Compact Oven SC

599 716 790 EN

New door safety switches in compact ovens with microwave from Schwanden

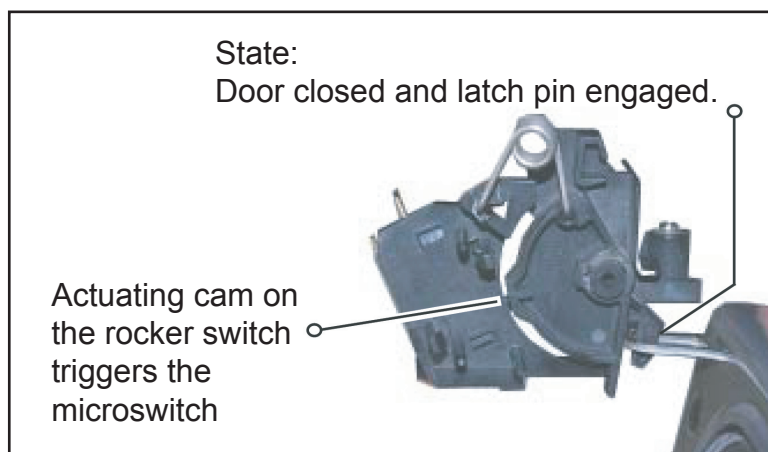
New door safety switches will be installed in compact ovens with a microwave part (model Schwanden PNC 944270....) from serial number 911.....

The latch pin mounted in the door has also been modified to prevent it rubbing against the retainer, the positioning of which has also been altered slightly.

Assembly when servicing:

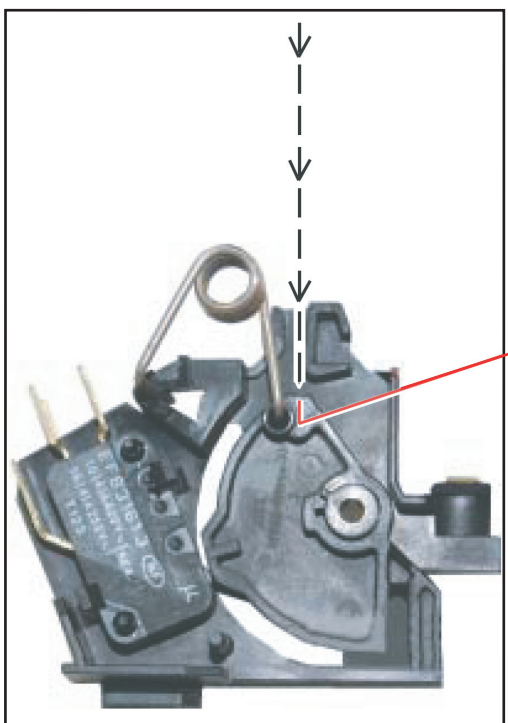
- Premount the door switch, but do not tighten the screws.
- Close the door.

- Move the door switch in such a way that the slot of the rocker switch is visible from above and is flush with the edge of the door switch housing.
- Tighten the screws in this position.
- Check the positioning using a screwdriver.
- Use a multimeter to check that the microswitches are working properly.

When servicing, the leakage on the appliance should be measured after replacing door switches and a safety check should be performed.
